#### SUBJECT: SI Work Plan Review C.M. Christiansen Project

### SI Work Plan Reveiw C.M. Chritstian Project April 26, 1995

## C.M.C Project (Coleman Schedule)

# C.M.C Project (WDNR proposed sched.)

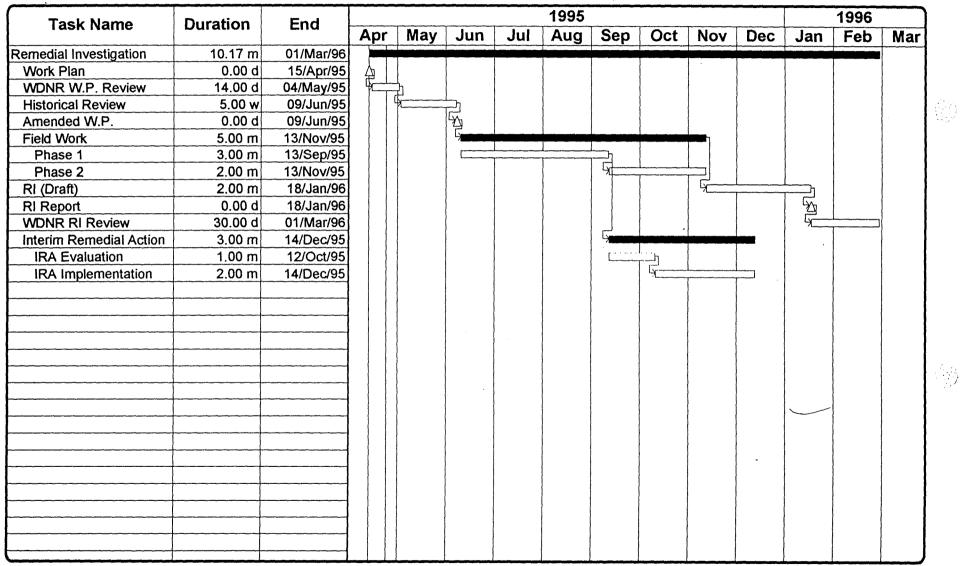
- P. 28 K) The USDA soil classification should be considered as a replacement for the USCS soil classification system. The USDA system may provide more appropriate information about soil characteristics relevant to pentachlorophenol contamination.
- P.33 0) The proposed schedule needs to be looked at for stream lining. Two issues exist with respect to the schedule. First, an evaluation of an interim remedial action should take place at the end of the phase I investigation. The evaluation must look beyond a passive bio assessment.

The second issue is to reduce the total time of the project. An alternate schedule has been proposed. The alternate schedule will allow time to design a remedial action in time for implementation in the 1996 construction season. The original schedule would potentially jeopardize this goal.
